Access Compliance Report

Public Rights-of-Way

(Curb Ramps)

Intersection ID: 19634	Main Street: E_INDEPENDENCE_BV	Cross Street: KREFELD DR	Location:	N
ADA ID: 3AABCE774F57	Ramp Type: Perp	Initial Pass/Fail: Fail	Overall Compliance: No	Severity Score: 17.5
Codes/Mitigation Info/Possible Solution		Field Measurements/Component Compliance

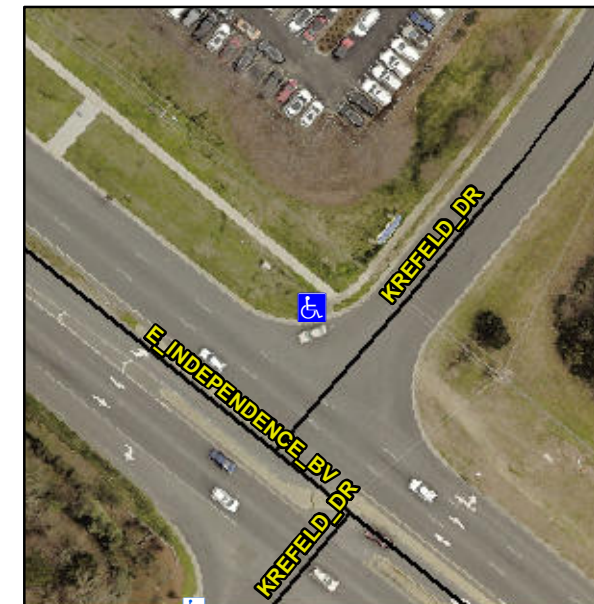
Not Found, R304.5.1

Compliance	Description	Data	Compliance	Description	Data
N/A	Ramp Length (in)	98.0	Yes	Ramp Slope (%)	5.6
No	Ramp Width (in)	34.0	Yes	Ramp XSlope (%)	0.4
N/A	Flare Type LT	N/A	N/A	Flare Type RT	N/A
N/A	Flare Slope LT (%)	N/A	N/A	Flare Slope RT (%)	N/A
N/A	Flare Traversable LT?	N/A	N/A	Flare Traversable RT?	N/A
N/A	Landing Length (in)	N/A	N/A	DWS Provided?	N/A
N/A	Landing Width (in)	N/A	N/A	DWS Contrast?	N/A
N/A	Landing Slope (%)	N/A	N/A	DWS Length (in)	N/A
N/A	Landing X Slope (%)	N/A	N/A	DWS Full Width?	N/A
N/A	Landing Curb? (Y/N)	N/A	N/A	DWS Offset (in)	N/A
N/A	Shared Landing?	N/A			
N/A	Gutter Ponding?	N/A	N/A	Gutter Slope (%)	N/A
N/A	Gutter Lip Ht (in)	N/A	N/A	Gutter X Slope (%)	N/A
N/A	Painted X Walk1?	No	N/A	Painted X Walk2?	N/A
	X Walk 1 Direction	To SE		X Walk 2 Direction	N/A
N/A	X Walk 1 Width (in)	N/A	N/A	X Walk 2 Width (in)	N/A
	X Walk 1 Slope (%)	3.2		X Walk 2 Slope (%)	N/A
	X Walk 1 X Slope (%)	1.6		X Walk 2 X Slope (%)	N/A

Remove & Replace Entire Ramp.
